**Re: Academy Village Filing No. 3 - Drainage Addendum Letter**

This letter is an addendum to the “Final Drainage Report for Academy Village”, dated April 1999, prepared by HMS Group, LLC. This addendum will address the reconfiguration of the drainage pattern within Basin 1a of the approved report. The purpose of this addendum is to quantify the changes to the drainage condition due to site variations from the approved report.

**DRAINAGE MAP - DEVELOPED ACADEMY VILLAGE EL PASO COUNTY, COLORADO**  
 PREPARED FOR:  
 EAGLE FLIGHT, LLC  
 TWO STEELE STREET, STE. 201, DENVER, CO 80206

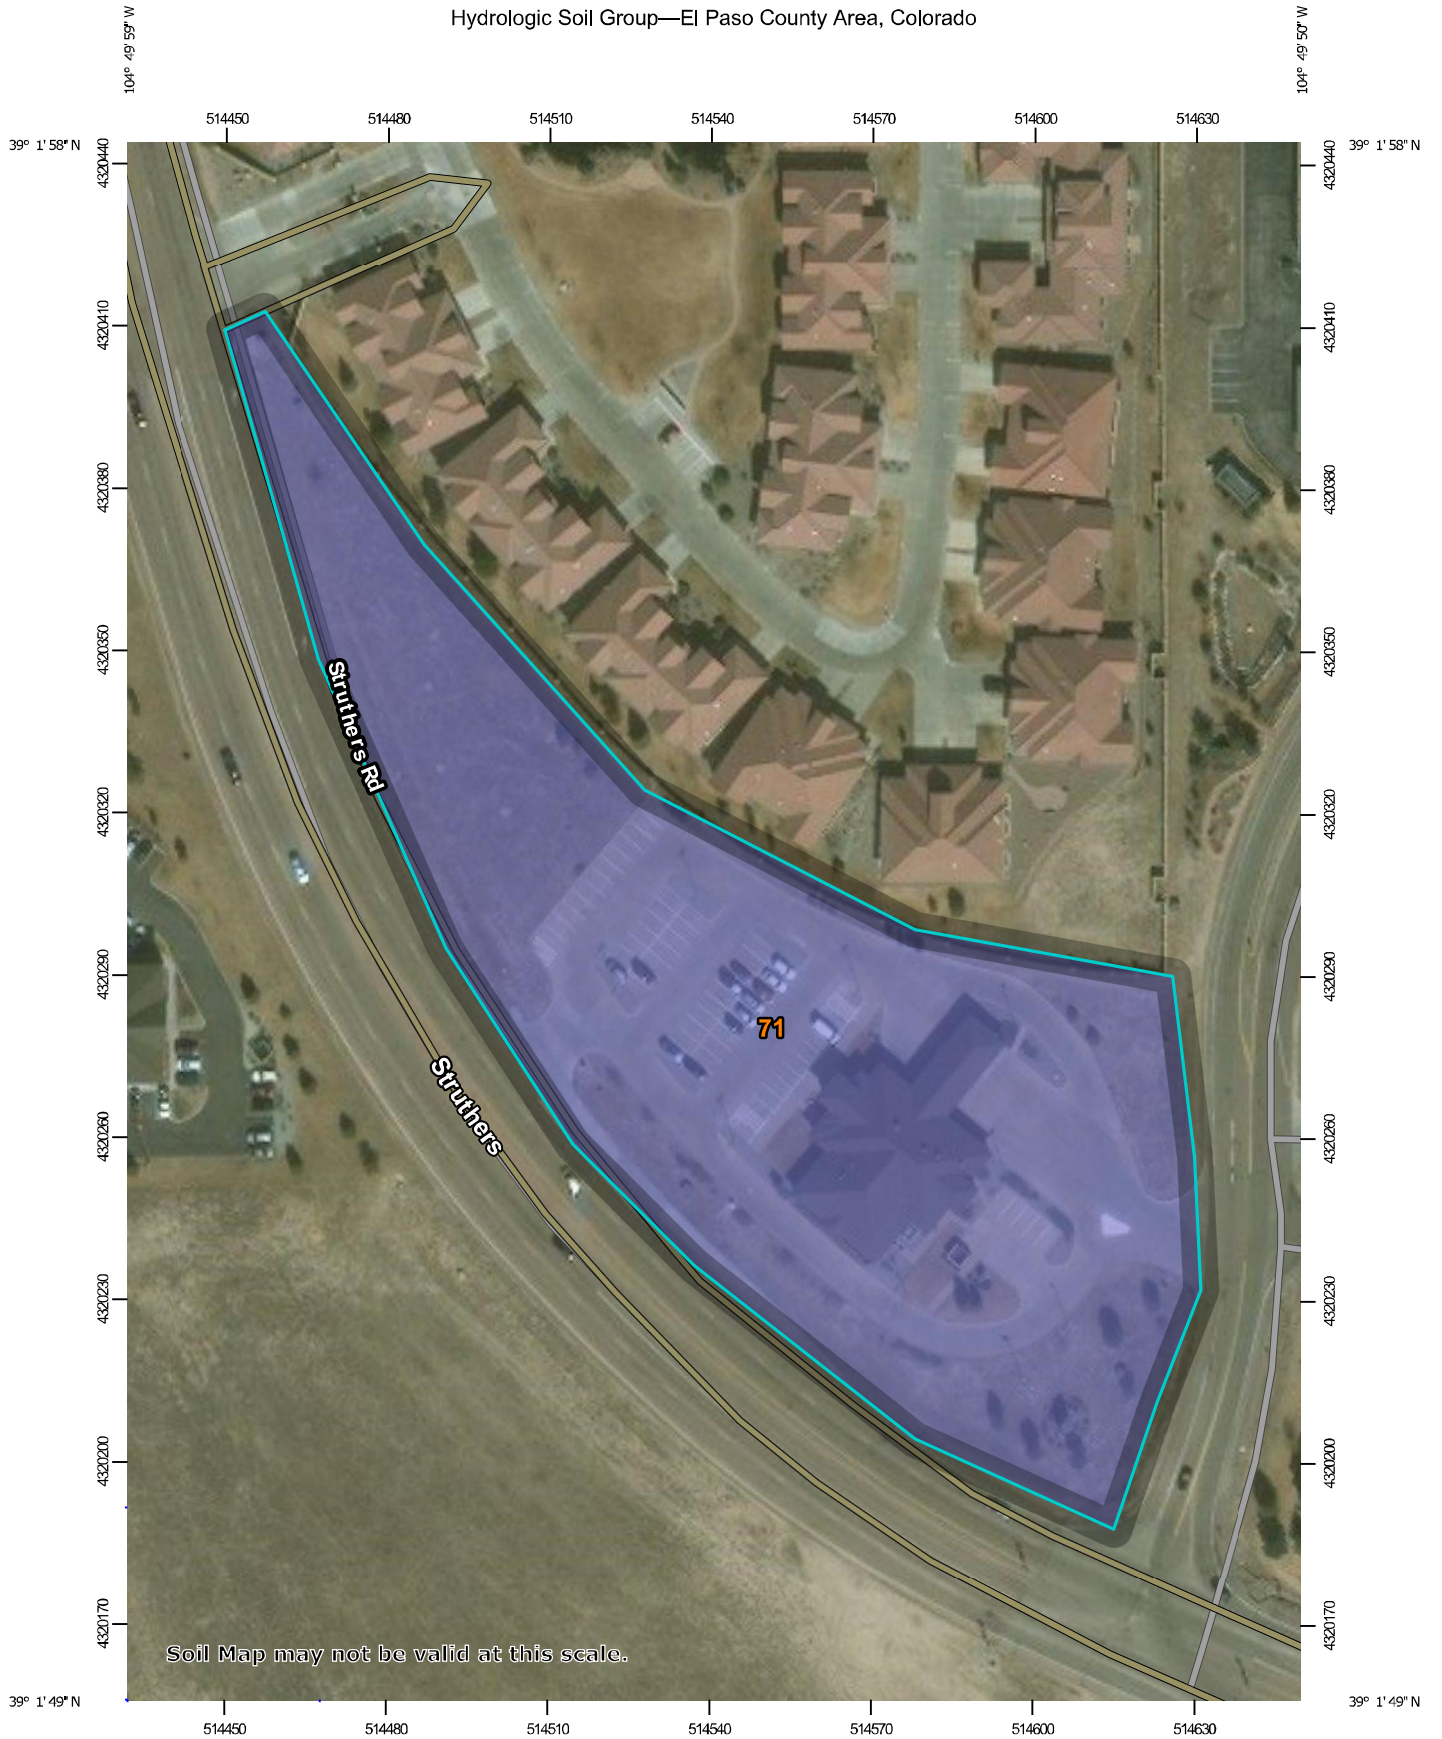
The site was originally intended to drain to a CDOT Type D Catch Basin located at the north end of the site. The Type D catch basin can be seen within the approved “Drainage Map – Developed Academy Village”, located in Appendix B. The existing site currently drains to two locations. The first site outfall is a 24” RCP with a flared end section located at where the Type D Catch Basin was originally planned to the northeast. The second site outfall is at a 24” RCP with a flared end section located northeast of the existing bank parking lot. Both 24” RCPs connect to an existing 54” RCP storm drain that flows northwest, ultimately outfalling to a detention pond west of Struthers Road, approximately 1,200 feet northwest of the site.

The proposed improvements have been designed with the intent to maintain the hydrology of the approved report. The approved report conveyed the generated runoff untreated to the existing 54” RCP. The proposed drainage condition for Academy Village will convey the generated runoff to an on-site water quality pond before ultimately outfalling to the same 54” RCP as in the approved report. The drainage map for Academy Village is located in Appendix B. Runoff from Basin A will be routed via curb and gutter, a natural swale, and a 12” PVC pipe to a water quality capture pond at the northern end of the site. The water quality pond is sized to treat 0.014 ac-ft, and release the treated runoff to the existing 54” RCP via a 12” RCP outfall. The runoff from Basin B will be collected in a natural grass swale that runs along the southeast edge of the site. Flows from Basin B will go to an existing 24” RCP that ties into the 54” RCP to the north of the site. All basin calculations can be found in Appendix A. The runoff from Basin OS1 is primarily sheet flow off of Struthers into the natural swale within Basin B.
